National Construction Code Assessment Report

PROJECT: **Laguna - North Lakes**

CERTIS REF
NO: BA17513

REVISION
NUMBER: 5

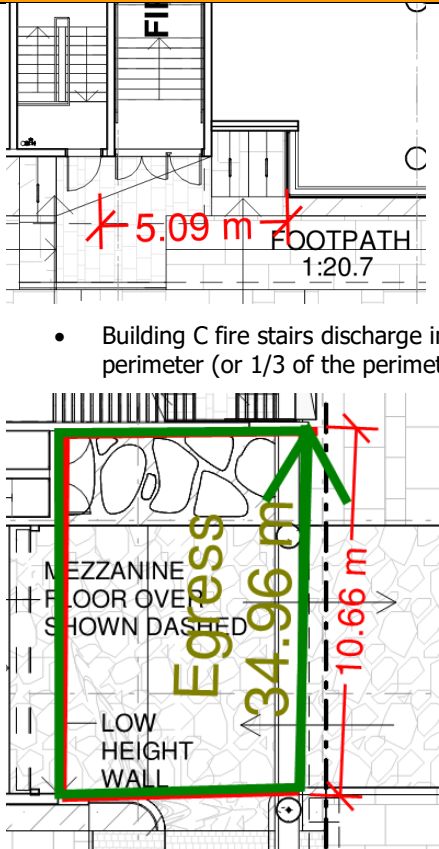
Clause	Title & clause summary	Assessment Comments	Status
D1.4	Exit travel distances <i>Class 2:</i> <i>the entrance of a unit must be no more than 6m to an exit or point of choice to alternative exits, or 20m to an exit at Ground</i> <i>common areas to be no more than 20m from an exit or point of choice to alternative exits</i> <i>Class 5-9:</i> <i>20m to an exit or point of choice to alternative exits with 40m total distance to one of those exits; or</i> <i>30m to a single exit at Ground Level (Class 5 & 6 only)</i>	Extended travel distances in the following locations: Function rooms– up to 44 m to an exit. Basement 2 – up to 55 m in lieu of 40 m. Chiller plant room – up to 55m in lieu of 40m EOT – up to 60m in lieu of 40m Basement 1 - up to 60m in lieu of 40 m. Function stores – up to 50m in lieu of 40m Lower ground level: - Up to 29 m to a point of choice and up to 49 m to road or open space from the retail tenancies. Upper ground level: - Up to 50 m to an exit from restaurant tenancies Building B – 30m to a point of choice (to allow tenant flexibility) Building C – 30m to a point of choice and up to 50m from function rooms Building D Level 1 – 35m to point of choice from fitness centre, 51m to an exit (allowing for fit out) Level 2 – Building B roof – 30 m to an exit in lieu of 20 m. Building E & F – up to 30m point of choice (to allow tenant flexibility) Extended travel distances may be able to be rationalised by a fire engineer as a performance solution.	Performance Solution

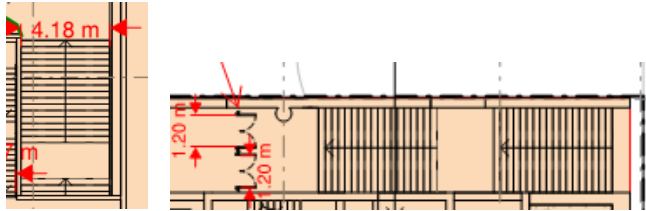
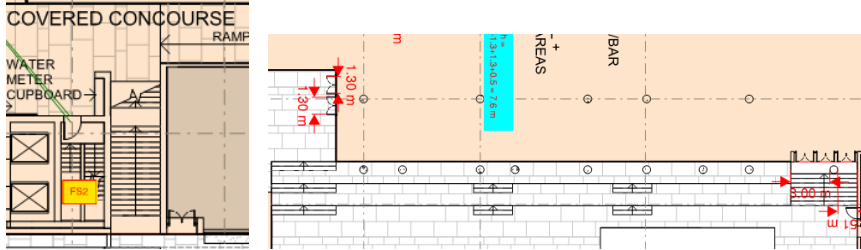
Clause	Title & clause summary	Assessment Comments	Status
D1.5	Distance between alternative exits <i>Must be not less than 9m apart; and not more than 45m apart for Class 2 and 9a; and not more than 60m apart in all other cases</i>	Distance between exits exceed in the following locations: Levels 3, 4, 5 & 6 hotel – 57 m in lieu of 45 m Basement 1 – 80 m in lieu of 60.	Performance Solution
D1.6	Dimensions of exits and paths of travel to exits <i>Unobstructed width of exit and path of travel to the exit must be not less than that prescribed</i>	Please find allowed population based on provided exit widths in the appendix. Please confirm if the population numbers are within the numbers allowed for based on the exit widths. Possible performance solution for reduced egress width	Further information required
